Manuscript Number: egusphere-2026-1378

Title: Managed Aquifer Recharge in Confined Multi-Layer Aquifers: A Scalable Framework for Drought Resilience in Central Europe

Response to the Reviewer #2:

Updated Figure 6

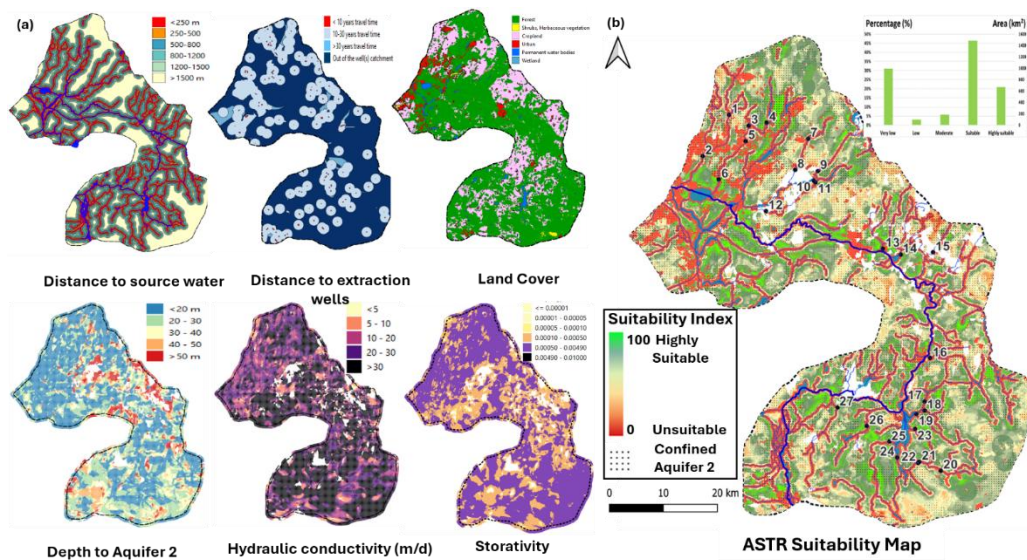
There is one main aspect that requires some more attention by the authors: they claim that their technique applies to confined aquifer systems such as Aquifer 2. In Chapter 3.4 they present the different criteria applied for the ASTR suitability assessment (L239 onwards). One criteria is storativity, a critical property within the context of MAR, especially if the aquifer system is confined, implying feasibility or efficiency of MAR measures. I do recommend that the areas with the aquifer 2 being confined to be outlined in Figure 6f and figure 10.

We thank the reviewer for this valuable suggestion. We have updated Figure 6 and Figure 10 to explicitly outline the areas where Aquifer 2 is confined (indicated by the dotted pattern in the legend). Furthermore, we have added a schematic diagram in the top-right corner of Figure 10 to illustrate the ASTR process, demonstrating direct injection into and recovery from the confined Aquifer 2. These visual additions clarify the feasibility of substantial storage volumes and the rationale behind our suitability criteria.

Updated Figure 10

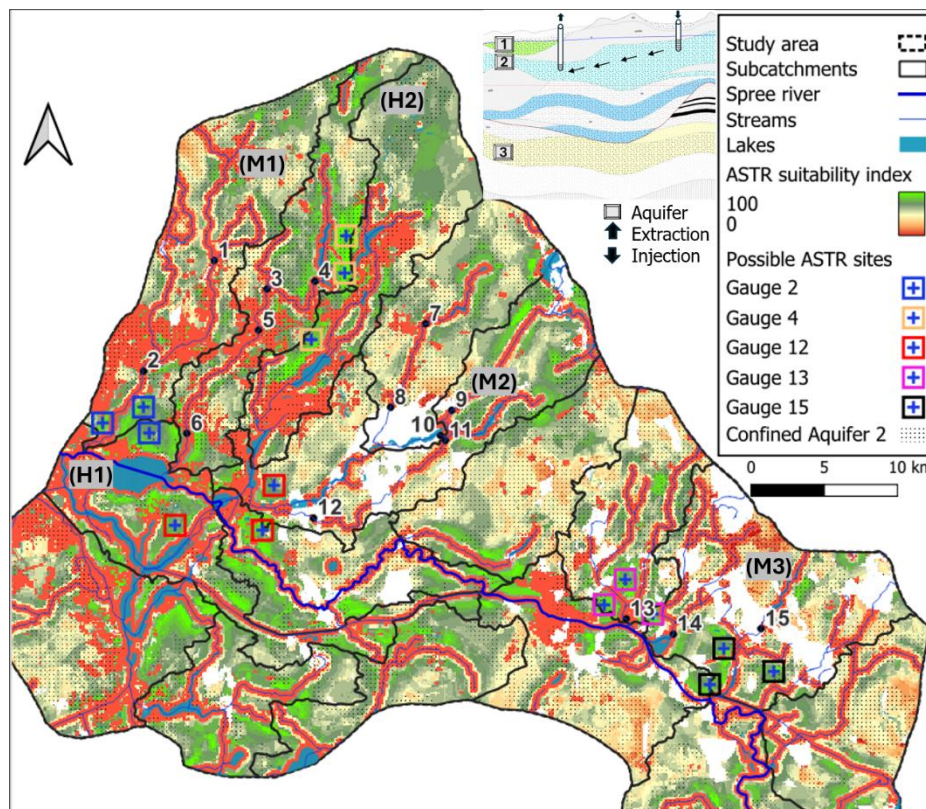
Should artificial recharge be accomplished via the unconfined Aquifer 1 and aquifer 2 be recharged via hydraulic windows, then, different criteria need to be selected on top. In order to clarify the concept for the reader, I recommend to the authors that they present a schematic diagram for different ASTR settings to demonstrate the feasibility of substantial volumes of storage, as well as the expansion of the suitability criteria. (schematic diagram in the Updated Figure 10)

We thank the reviewer for raising this important conceptual point. As clarified in the updated schematic diagram (Figure 10), our framework specifically evaluates direct injection and recovery within the confined Aquifer 2. Because the study focuses on this direct pathway, the current suitability criteria (e.g., Aquifer 2 storativity and hydraulic conductivity) are fully appropriate. We have added a clarifying sentence in Section 3.4 to explicitly distinguish the evaluated direct ASTR setting from the indirect pathway via Aquifer 1, explaining why the criteria were not expanded to cover the latter.

Updated figure 5c

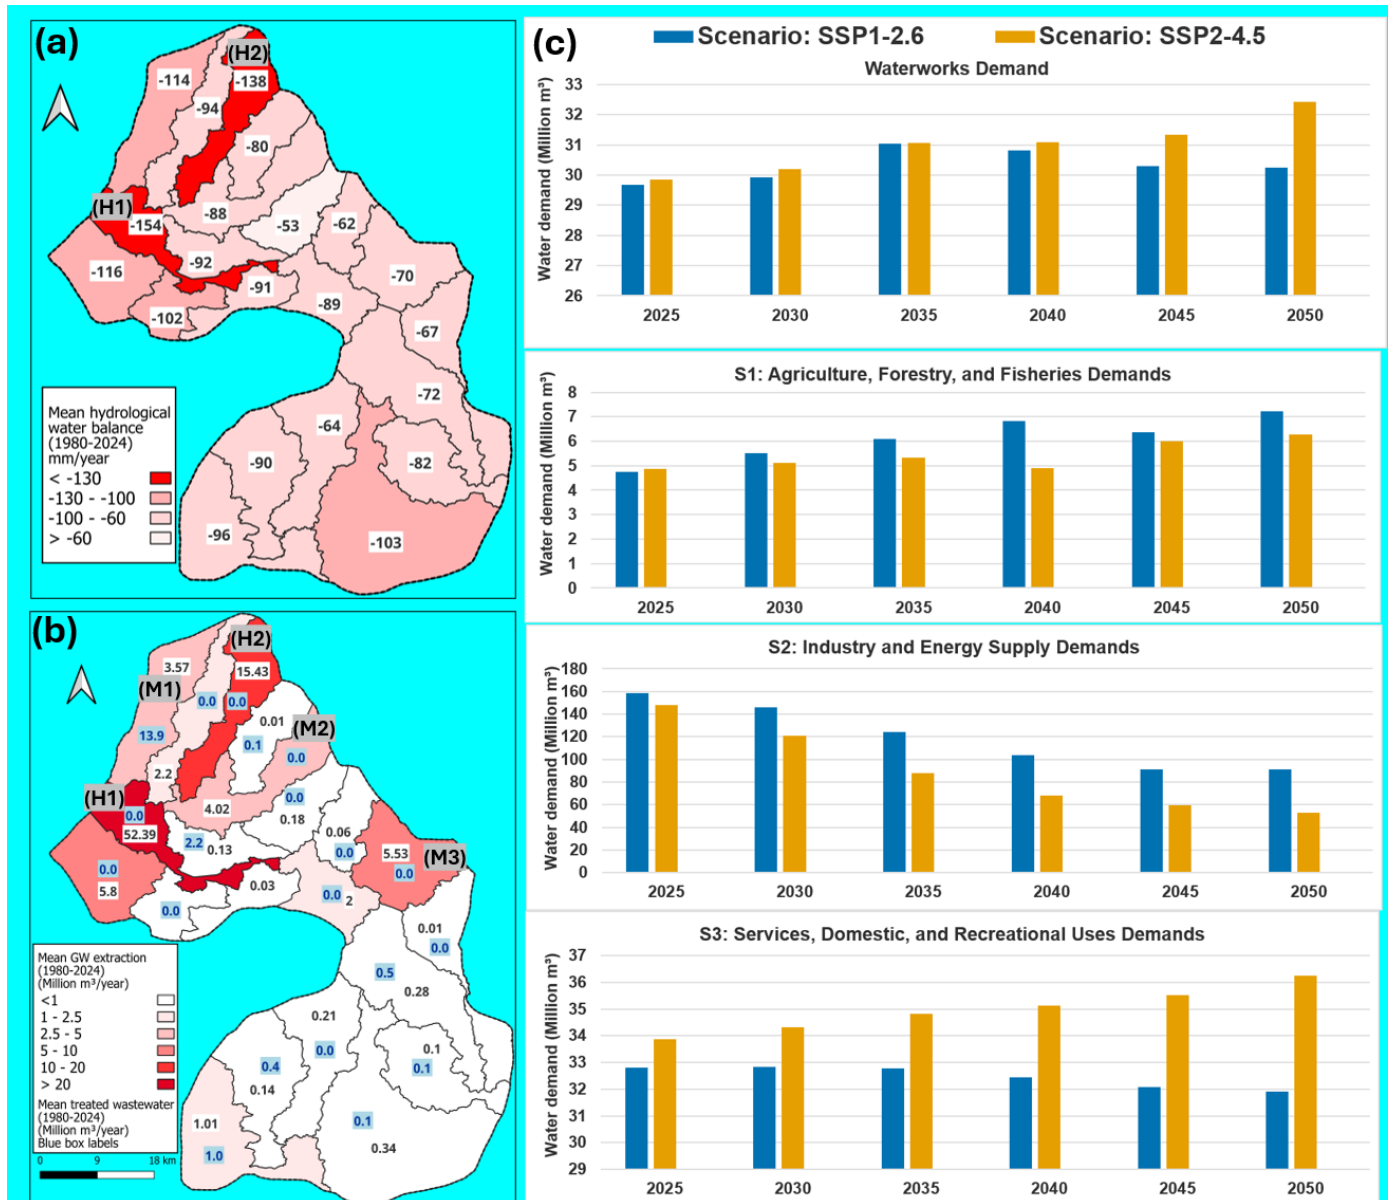
L227: RCP8.5 is highly unlikely; needs a statement, why it is considered here.

We thank the reviewer for raising this important point. We acknowledge that the reference to RCP8.5 was incorrect. In this study, we do not use RCP-based results; instead, we consider socio-economic development pathways based on the SSP framework (specifically SSP1-2.6 and SSP2-4.5), consistent with IPCC AR6. We have entirely removed RCP8.5 from all calculations, figures, and text in the manuscript. To address the specific points raised:

We analysed projected water-demand scenarios for 2025-2050 and found a moderate but steady increase in total waterworks demand across the considered scenarios (Fig. 5c). Under SSP1-2.6, total waterworks demand fluctuates around 30-31 Mm³, while the most-likely SSP2-4.5 scenario shows a modest increase from ~30 to ~32 Mm³ by 2050. This spread (~1-2 Mm³) defines the stress-test range for storage and recovery capacity under realistic future conditions.

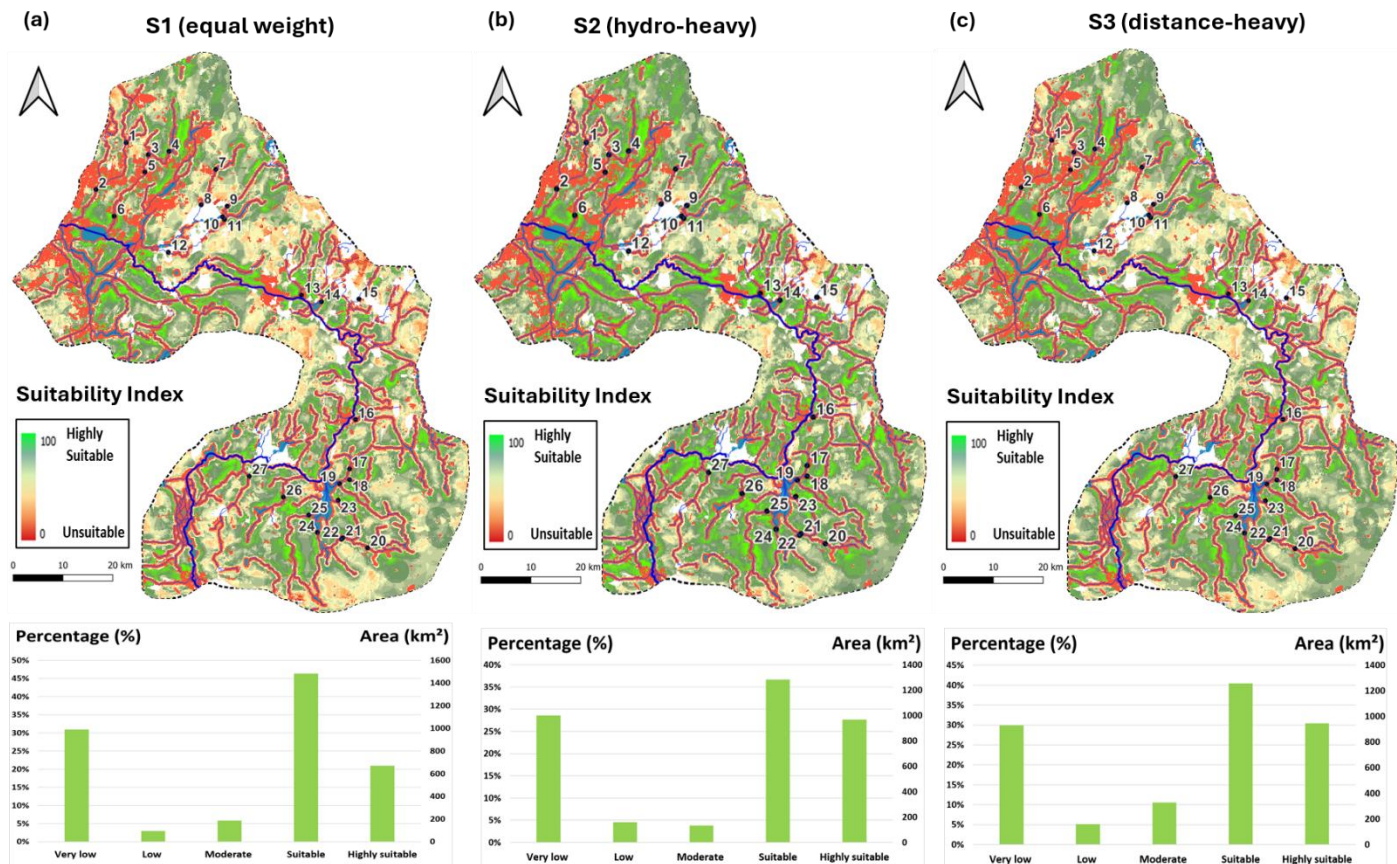
- Is there any weighting considered between the different criteria

Sensitivity Analysis Results: We tested three weighting scenarios (Table 2). Results demonstrate high robustness (Fig. 6; Table 3). The "Very Low" suitability class remained stable at ~29% across all scenarios (variation <0.3%), indicating physical constraints consistently define unsuitable areas. The "Suitable" class showed moderate variation (36.7-43.3%; $\Delta = 6.6\%$), while "Highly Suitable" areas varied between 17.2% (S3) and 27.7% (S2) ($\Delta = 10.5\%$).

Despite percentage variations, the spatial distribution of high-suitability zones remained geographically consistent across all scenarios (Fig. 6a-c), confirming that site suitability is primarily controlled by underlying physical characteristics rather than subjective weight assignment (Hani et al., 2023; Vandala and Mahed, 2025).

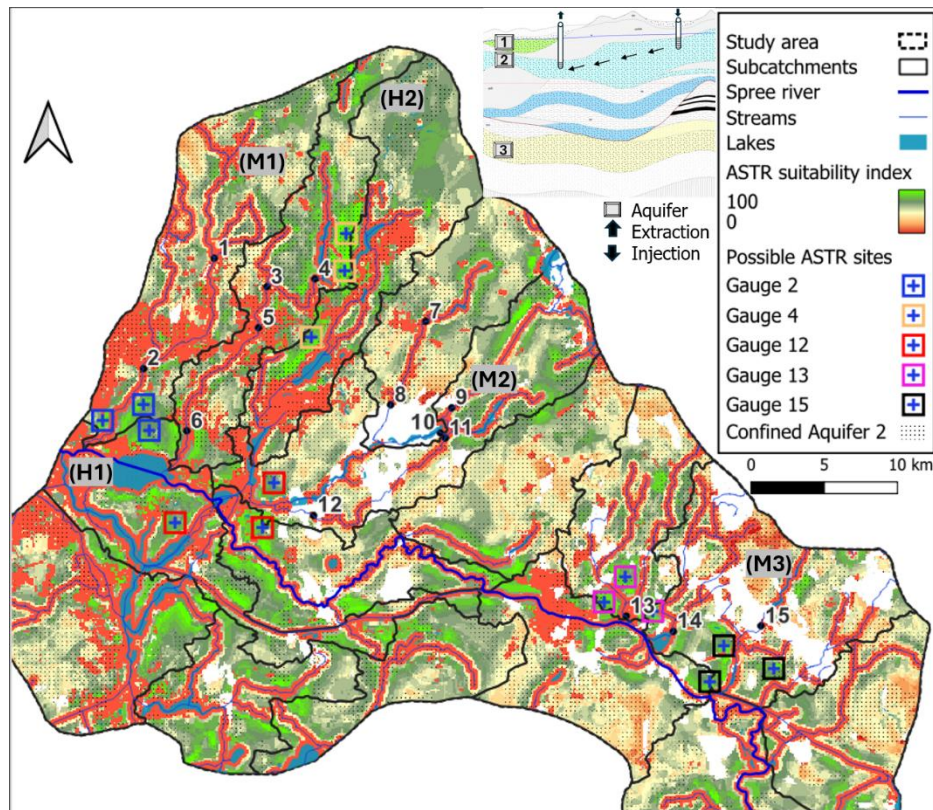
L231: Schematic Diagram of ASTR – Process needs to be included

We have added a direct reference to the ASTR process schematic diagram (now included in Figure 10). This ensures the reader is immediately guided to the visual explanation of the direct injection and recovery process in the confined Aquifer 2.
